October 9, 2014

To: Mike O'Dowd
Allston I-90 Interchange Improvement Project
Project Manager

RE: **MassDOT Highway Division
Allston I-90 Interchange Improvement Project
8th Taskforce Meeting
Meeting Notes of October 1, 2014**

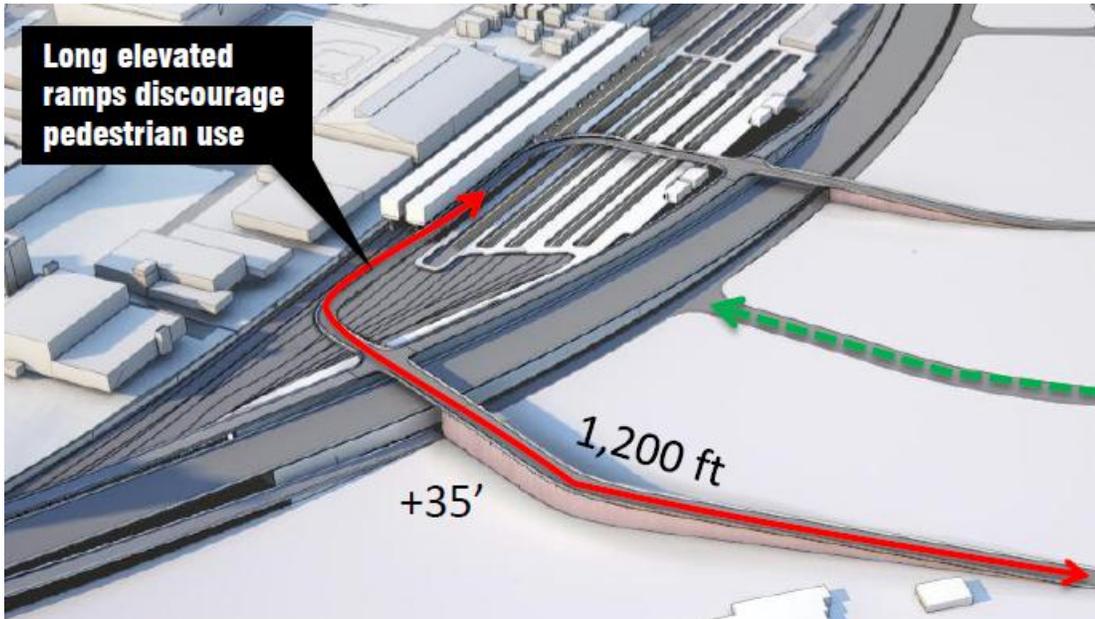
I'd like to take a moment to suggest that this analogy does not apply to this project. Here's why...

The Mass Pike in Allston is part of a system, which is the Mass Pike Extension from the Weston Tolls to I-93 and the airport. When the system is constrained in one location, that constraint applies to the entire system. Sort of like "a chain is only as strong as its weakest link". Without a feasible scenario to increase the clearance under the Pru and throughout the entire system, it is hard to find any utility of building a higher clearance in the Allston portion of the system.

The clearance at the Prudential Tunnel for rail is 16' 9". Perhaps there are places on the Pike Extension where the rail clearance is even lower. For this project in Allston, my understanding is that MassDOT is using a design clearance for rail of 18' 6", which is 1' 9" higher than the Pru Tunnel.

The Great Wall

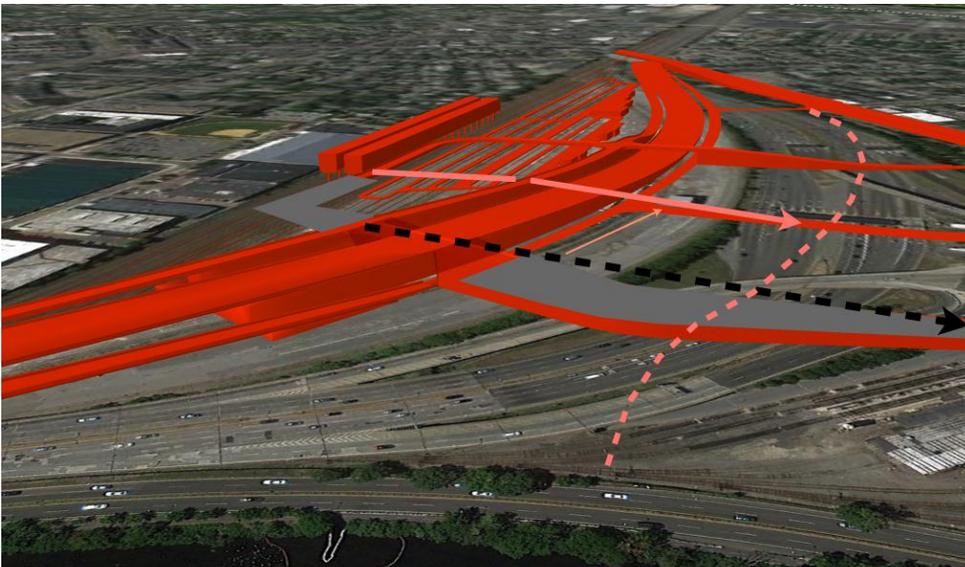
Just a quick follow up to my earlier comment about the ramp design. These two images capture the urban planning dilemma created by the Great Wall as I've taken to calling it. I'm sure there are some logical transportation reasons for deploying the ramps in this manner but the price you pay in term of urban design and place-making is very steep (no pun intended). The BSA model illustrates the problem. I'm sure the team is well aware of this by now and working on it.

A three story high ramp wall bisects and disrupts the site

Moving back or eliminating the eastern most ramp
